CITY OF LINCOLN/LANCASTER COUNTY PLANNING STAFF REPORT

P.A.S.: Fallbrook 4th Addition Final Plat No. 02034 DATE: October 17, 2002

Subject: Final Plat #02034

Fallbrook 4th Addition

FALLBROOK 4TH ADDITION

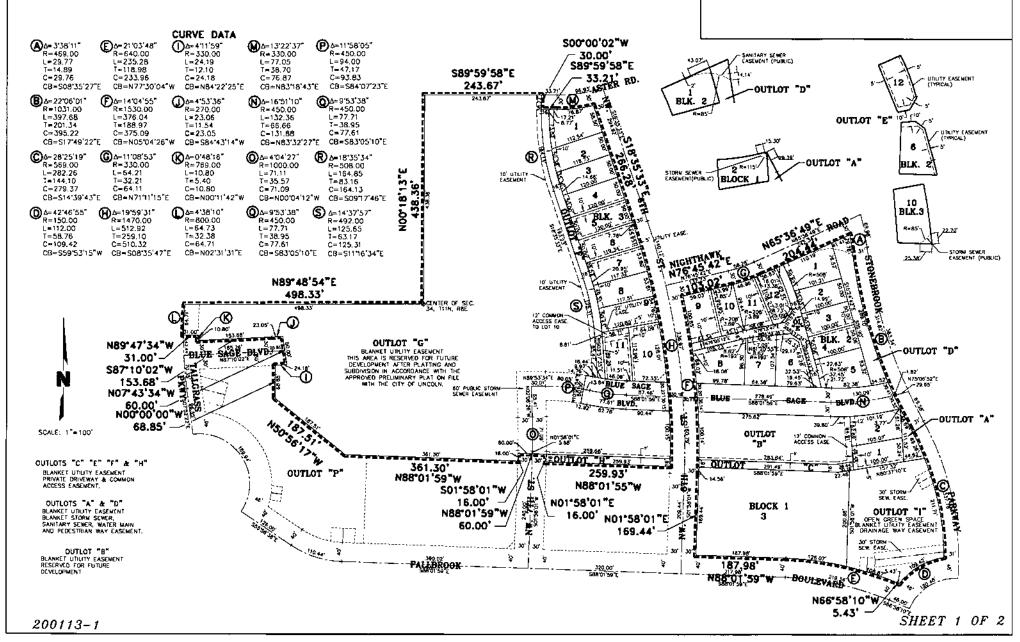
The City Engineer's Office of the Department of Public Works and Utilities has reviewed the Final Plat for Fallbrook 4th Addition located approximately at Northwest 6th Street and Blue Sage Boulevard. Public Works has the following comments:

- Storm Sewer The storm sewer system approved with the preliminary plat is satisfactory. An estimate of \$22,000 has been calculated in conjunction with a proposed executive order for the cost of the construction of the storm sewers within this addition.

- Street Paving The street paving approved with the preliminary plat is satisfactory. An estimate of \$64,800 has been calculated in conjunction with a proposed executive order for the cost of the construction of the street paving within this addition.

- Private Alley Paving The private alley paving approved with the preliminary plat is satisfactory. An estimate of \$9,600 has been calculated in conjunction with a proposed executive order for the cost of the construction of the private alley paving within this addition.

- Water Mains The water mains approved with the preliminary plat are satisfactory. An estimate of \$22,000 has been calculated in conjunction with a proposed executive order for the cost of the construction of the water mains within this addition.

- Sanitary Sewers The sanitary sewer system approved with the preliminary plat is satisfactory. An estimate of \$44,200 has been calculated in conjunction with a proposed executive order for the cost of the construction of the sanitary sewers within this addition.

- Ornamental Lighting A \$7,300 bond should be required for the installation of the ornamental lighting within this addition.
- Sidewalks A \$50,400 bond should be required for the construction of the sidewalks within this addition.
- Survey Markers A \$2850 bond should be required to guarantee the placement of the
 permanent survey markers within this addition as required in the Surveyor's Certificate
 where temporary markers have been placed or provided the Surveyor's Certificate is signed
 and sealed that the permanent survey markers have been found or set on all boundary
 corners, street intersections, block corners, points of tangency and curveature and all lot
 corners have been placed, a staking bond will not be required.
- Street Signs A \$230 bond should be required for the installation of street signs within this
 addition.
